MODEL: C2

SUBJECT: CHASSIS PDM POWER CABLE CHAFING

DATE: JUNE 29, 2012

BULLETIN: 13

FIGURE 1

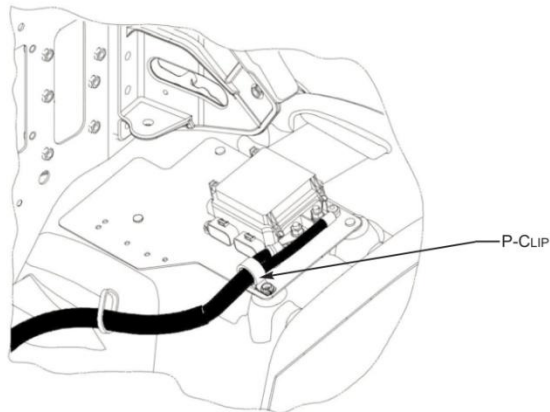
Inspection: Check the unit for the presence of a P-Clip as shown in Figure 1. If P-Clip is present, no further action is required.

FIGURE 4

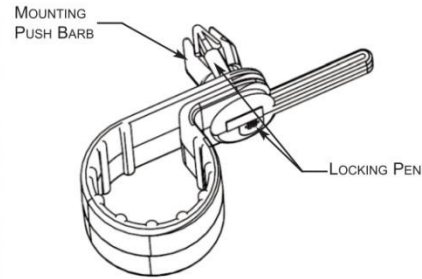
7. Locate the unused hole in the PDM mounting plate close to the power cable. **Figure 3**
8. Open the P-Clip (TBB 61480924) and install around the chassis PDM power cable that is closest to the unused hole. **Figure 4**
